CITY OF ALBUQUERQUE

May 28, 2024

**RE: Event Center
1611 Airtech Ct. SE
Grading and Drainage Plans
Engineer's Stamp Date: 05/14/24
Hydrology File: N15D017**

Based upon the information provided in your submittal received 05/15/2024, the Grading & Drainage Plans **are not** approved for Building Permit and Grading Permit. The following comments need to be addressed for approval of the above referenced project:

SHEET TITLE
**STORM DRAIN
PLAN & PROFILE**

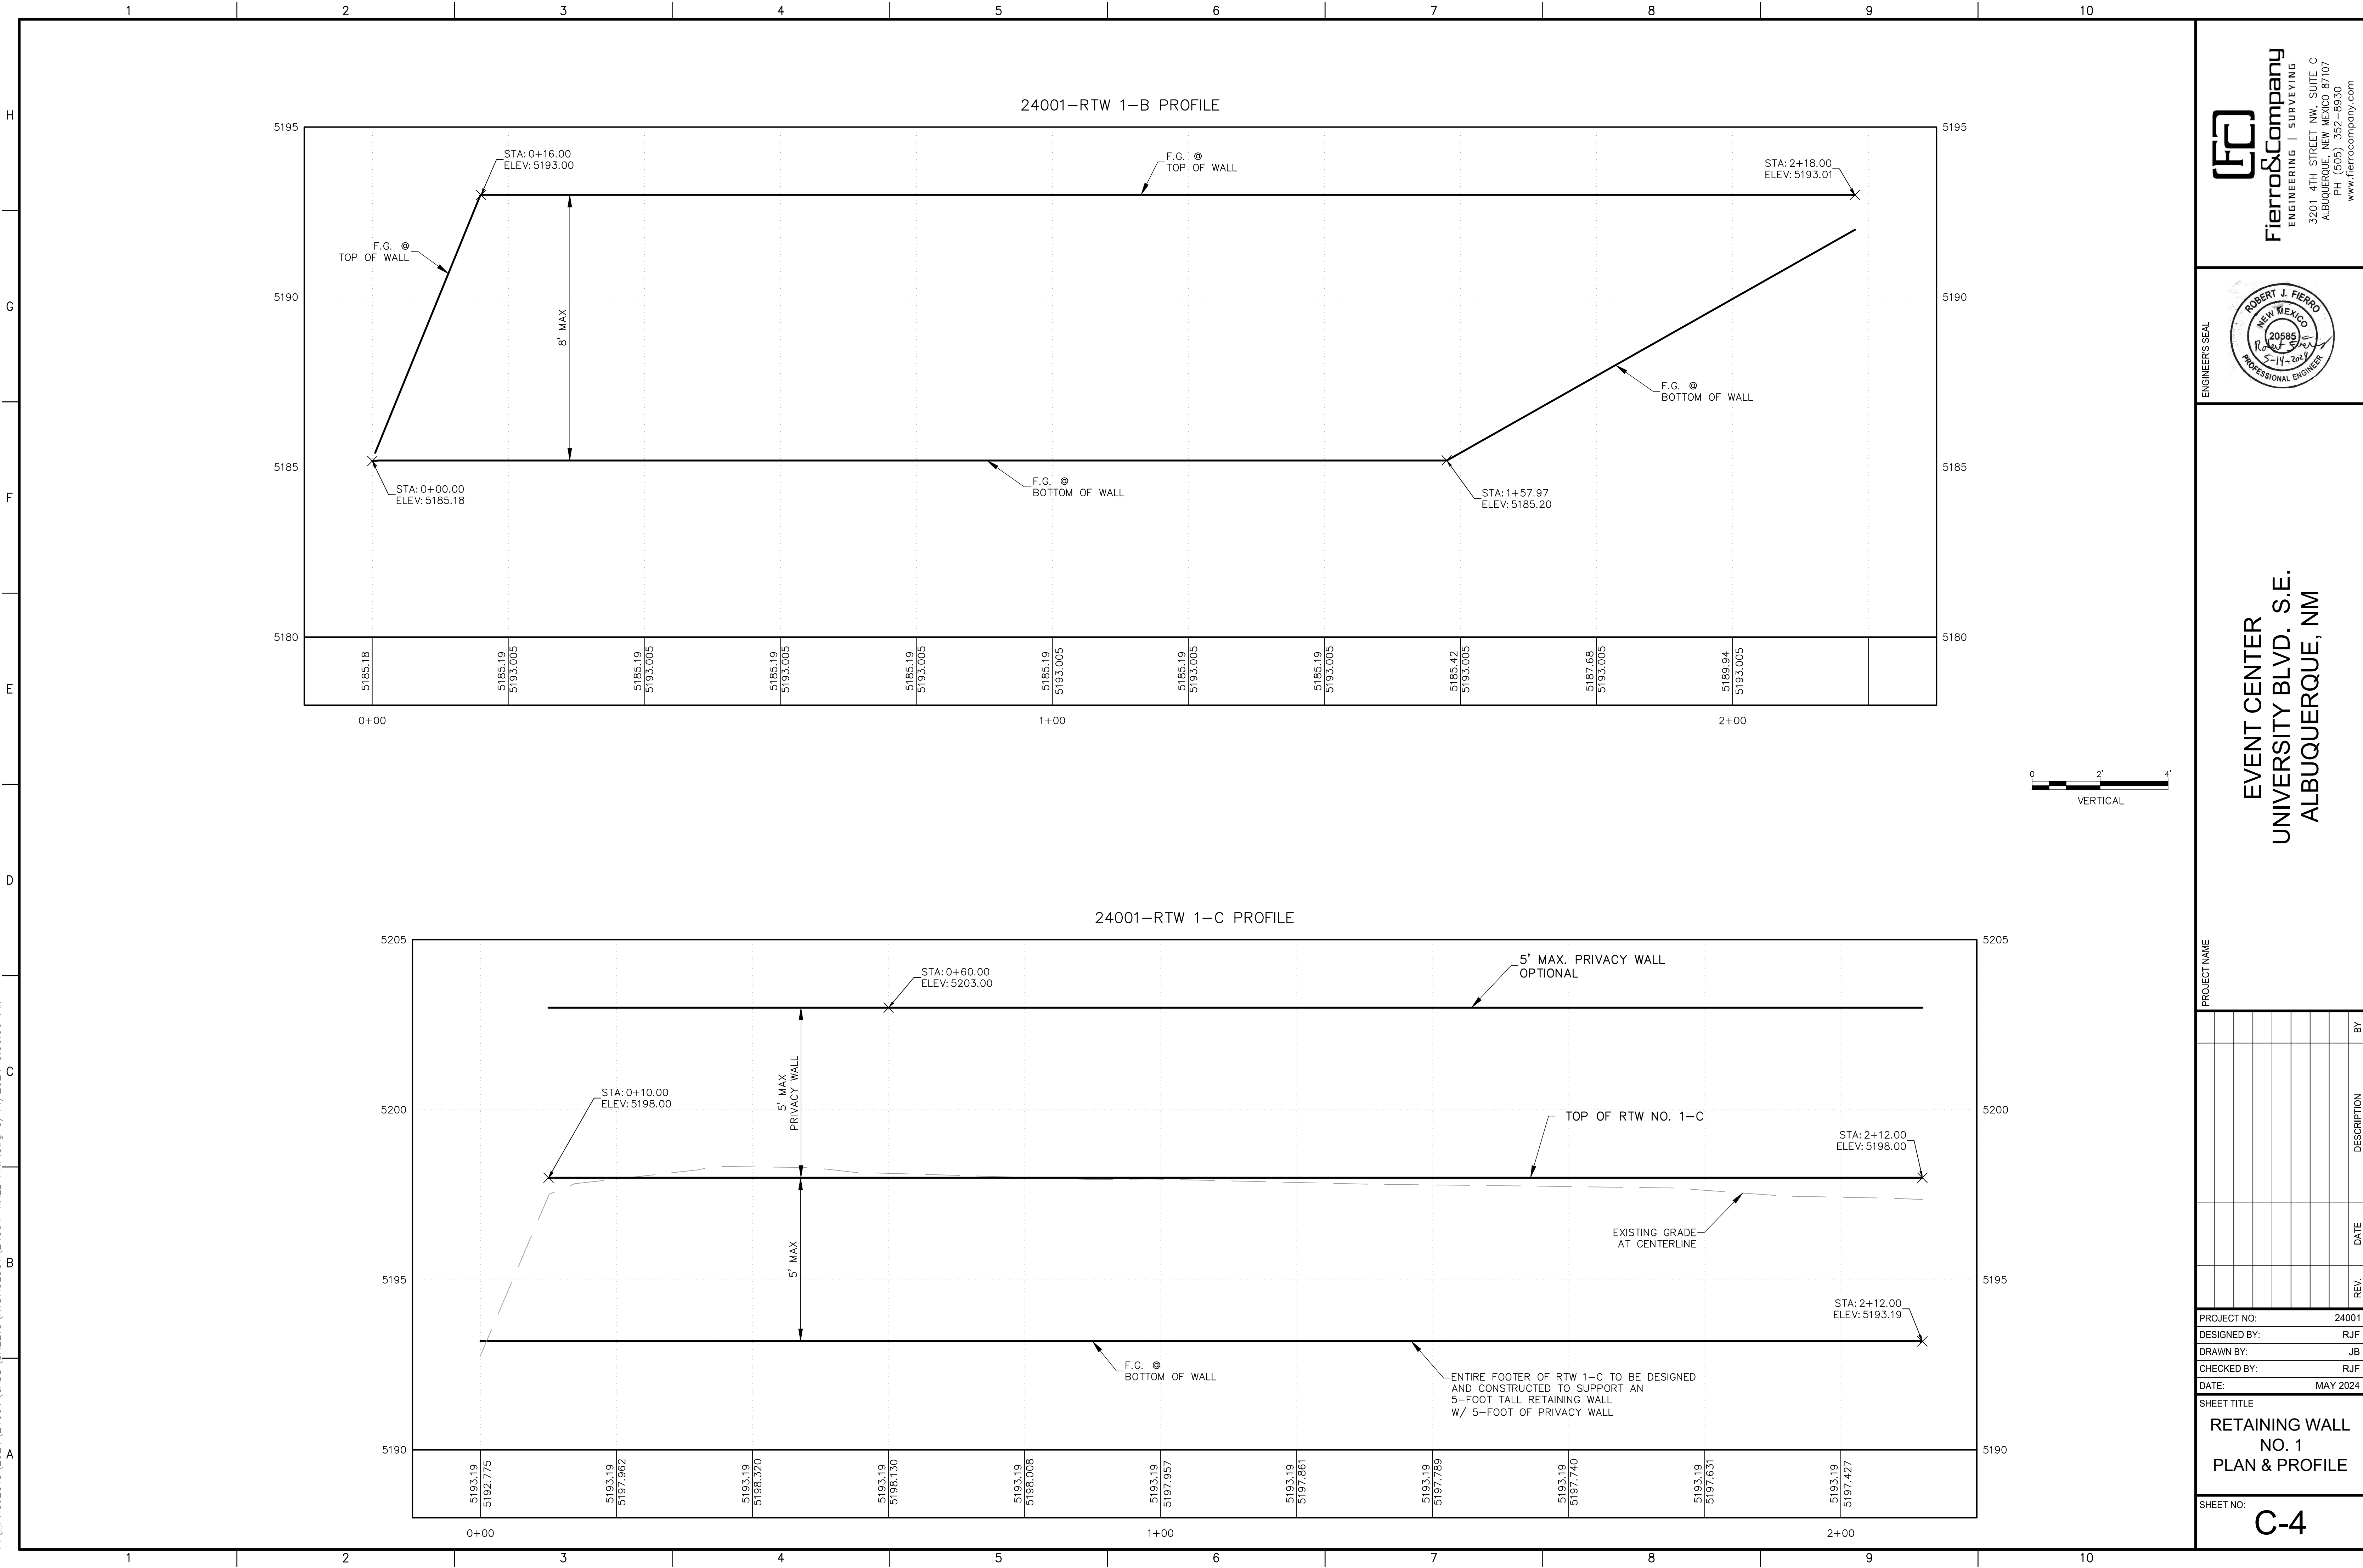
4. Please note that adjusting the elevation to the existing manhole will also be required to be included in the Work Order since this is more than a simple adjustment. It appears that it will have to be moved up about 10 feet.

5. I would highly recommend that the existing manhole rim elevation be topo'd along with the inverts of the 60-in storm sewer.
6. Also looking at the as-builts and the amount of fill that is being brought in on top of the existing 60-inch RCP Class III. This will have to be replaced with a 60-inch RCP Class IV due the cover and original installation.

SHEET TITLE
DRAINAGE PLAN

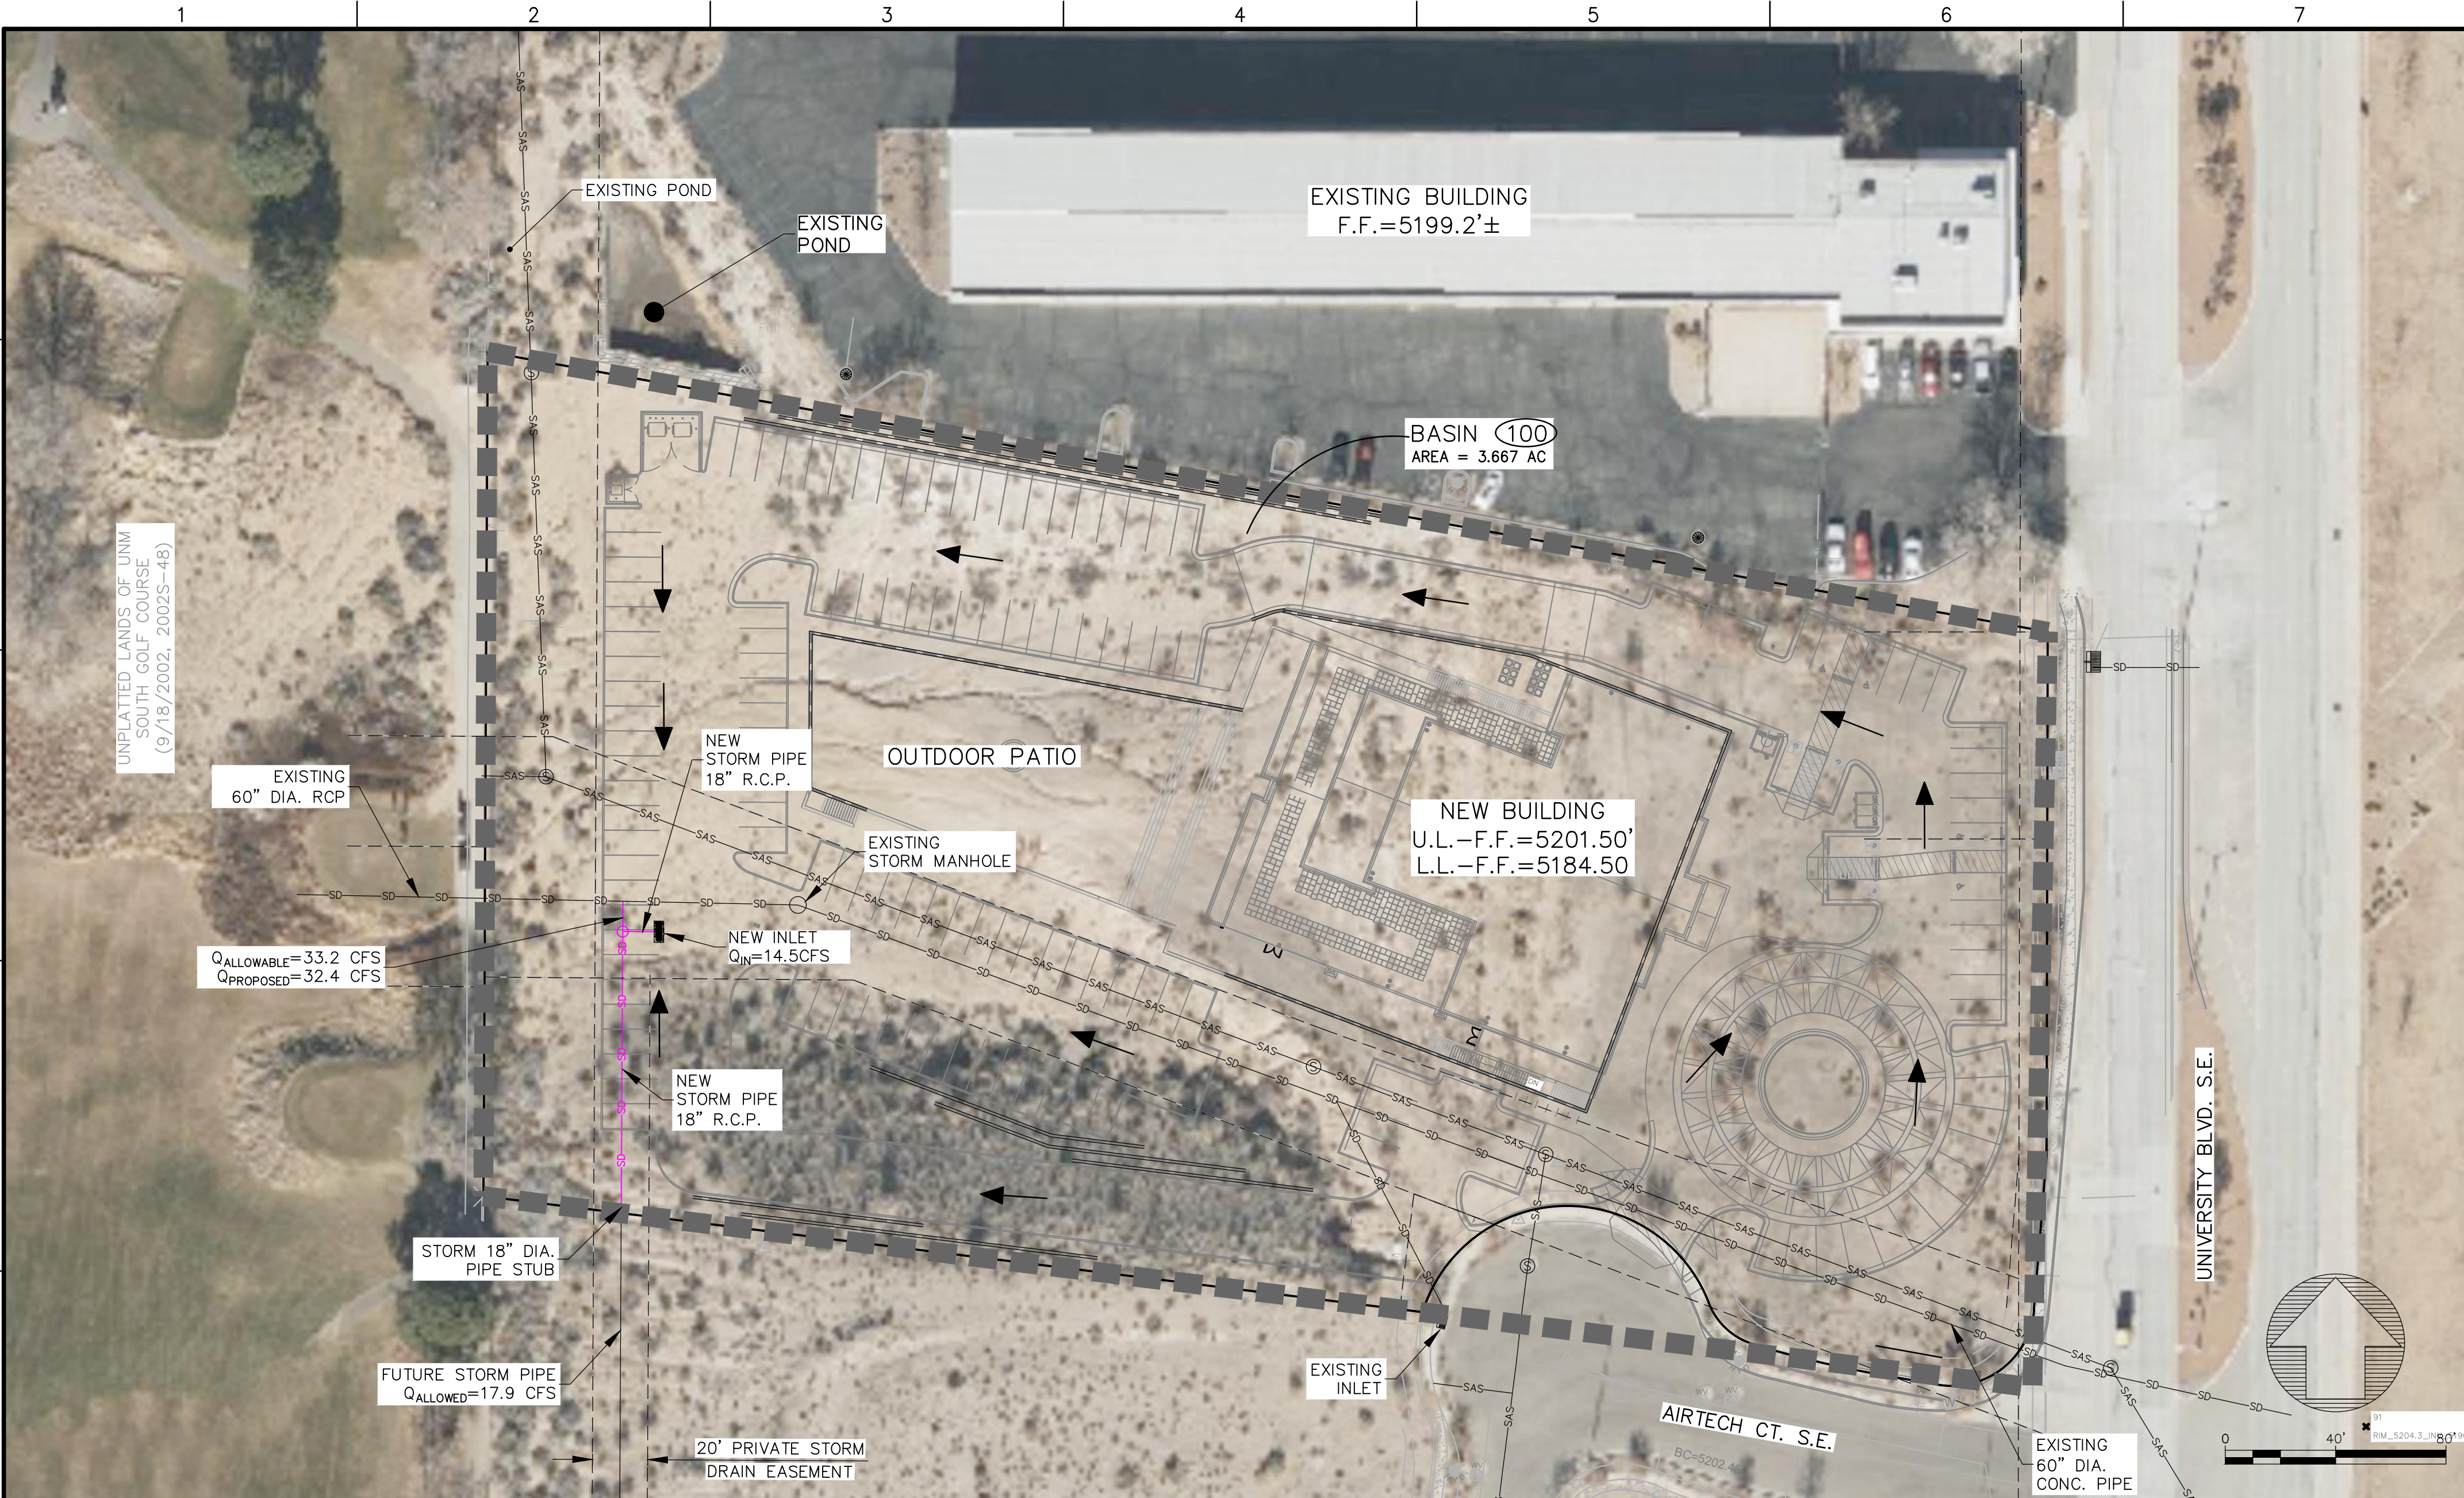
10. On the Drainage Plan under the Existing Conditions, please state that this tract is within the Master Drainage Plan for Lots 6B-2 and 8B, Airport Technical Center with an allowable discharge rate of 16.4 cfs.
